## DEVIATION REQUEST AND DECISION FORM

Project Name : Sterling Ranch Filing No. 5  
Schedule No.(s) : 5233302049  
Legal Description : Sterling Ranch Filing No. 5 Being a replat of Tract B, Branding Iron at Sterling Ranch Filing No. 2, located in the southwest quarter of Section 33, Township 12 south, Range 65 west of the 6th P.M. County of El Paso, state of Colorado

A deviation in accordance with the Paving Season 2024 – UPDATED is requested.

A deviation in ECM D.4.1.F is requested to use a composite section of asphalt and cement treated subgrade (CTS) as opposed to a composite section of asphalt over aggregate base course.

**FIG. 1**

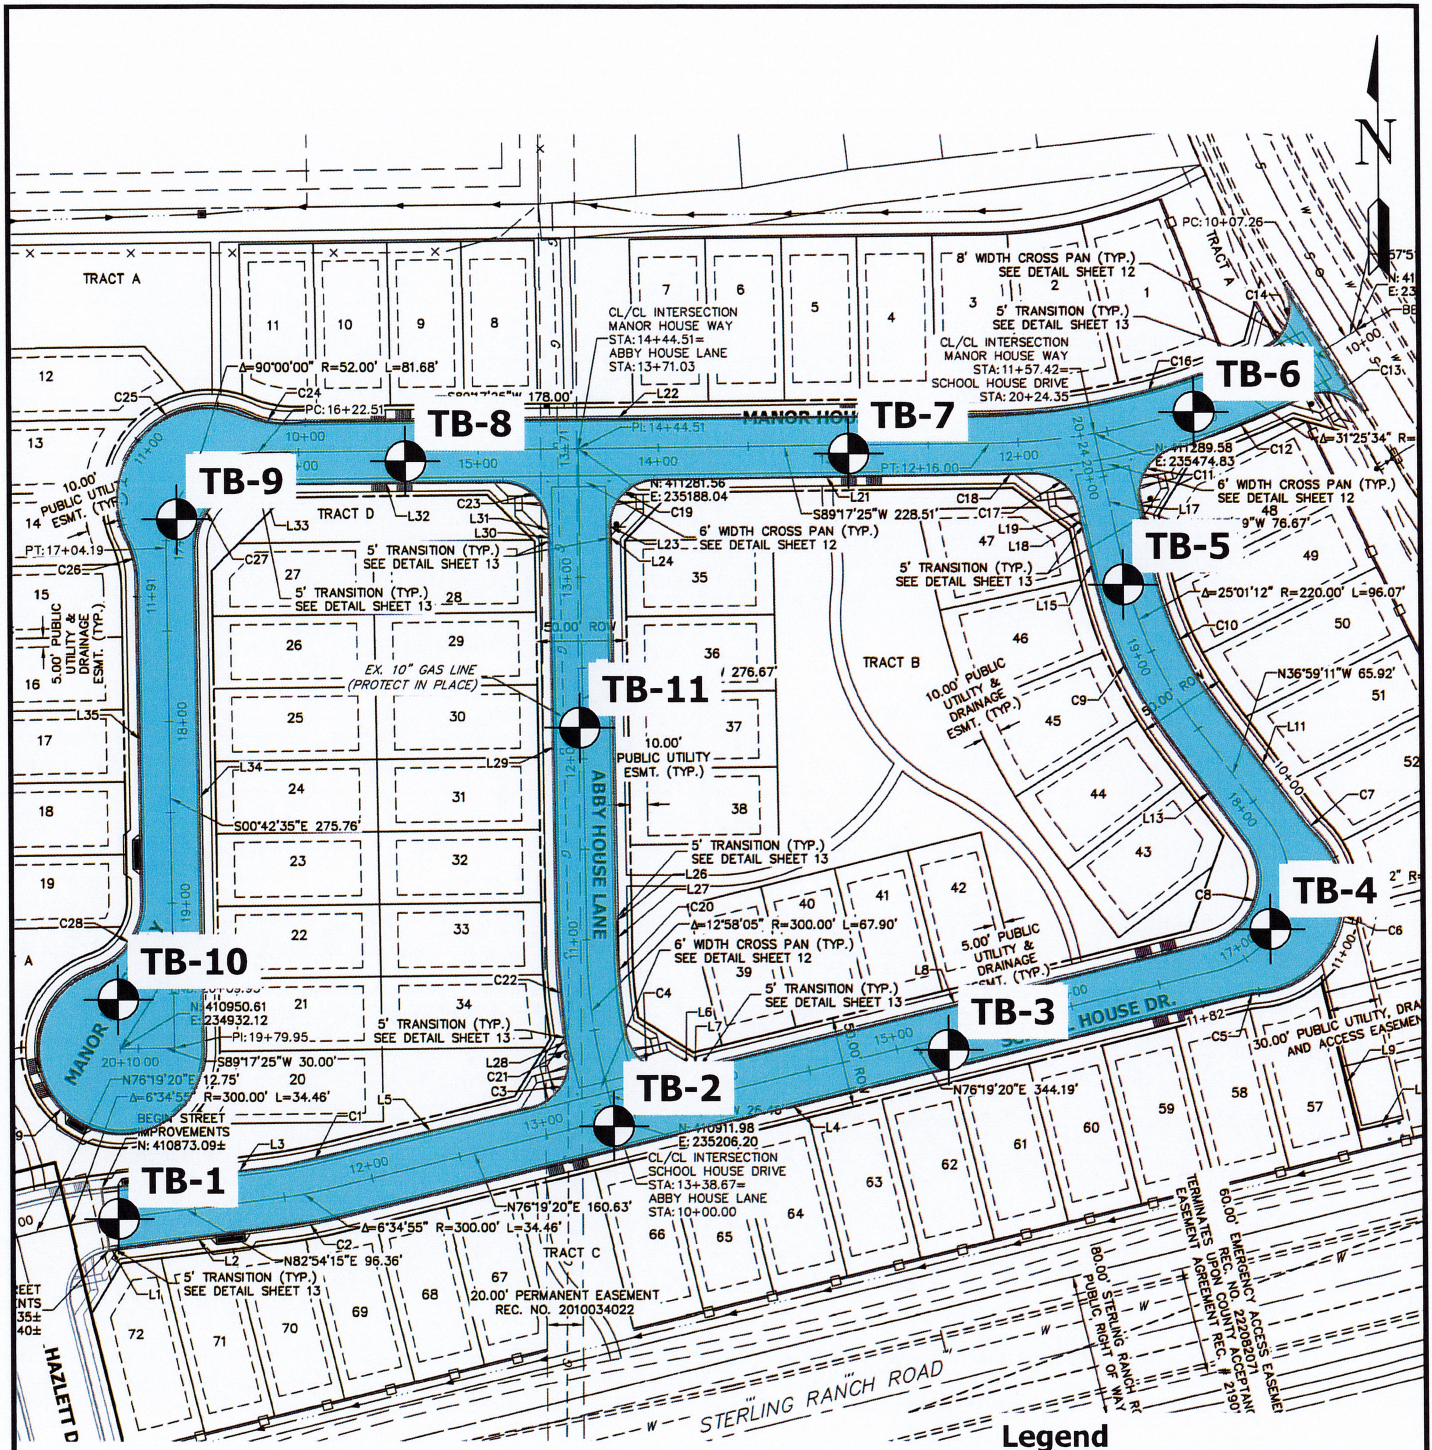
The proposed alternative includes the use of cement treated subgrade (CTS) as a base layer for the hot mix asphalt pavement section. ECM layer coefficients presented in Table D-3 (CTS strength coefficient = 0.11) was used for design of the pavement section. The overall structural number for the proposed section of HMA over CTS is 2.2 which exceeds the required structural number of 2.08.

An exhibit displaying the areas to include CTS is attached with this deviation request.

As described above, the required Structural Number of 2.08 is exceeded with a composite section of 3.0 inches HMA over 8.0 inches CTS with no compromise to public safety or accessibility. ECM layer coefficients presented in Table D-3 (CTS strength coefficient = 0.11) was used for design of the pavement section. The design structural number of 2.2 exceeds the required structural number of 2.08.

This request has been determined to have met the criteria for approval. A deviation from Section D.4.1.F. of the ECM is hereby granted based on the justification provided.
